ADDENDUM NO. 1

PROJECT NAME: COLISEUM ROOF
UNL PROJECT NUMBER: C010P166

DATE OF ISSUANCE: 03/23/2012
DATE OF BID OPENING: 03/28/2012

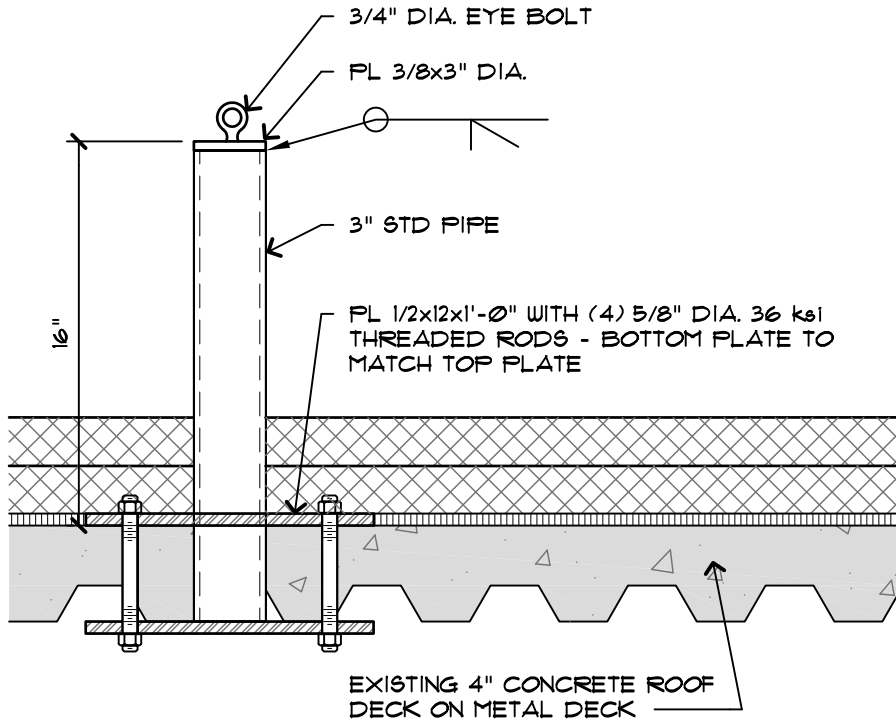
- A. Roof Plan: The height of the roof is approximately 35' at the southwest and southeast corners of the barrel vaulted roof; 45' at the northwest corner of the barrel vaulted roof; 90' at the tall gable roof. See attached elevation photo.
- B. Add: Detail 6 Fall Protection. New Roof Notes Add: key note no. 15. Roof Plan Add: key note tag no. 15 (3 locations). See attached drawings.

approximately 90'
above grade

approximately 45'
above grade

approximately 35'
above grade
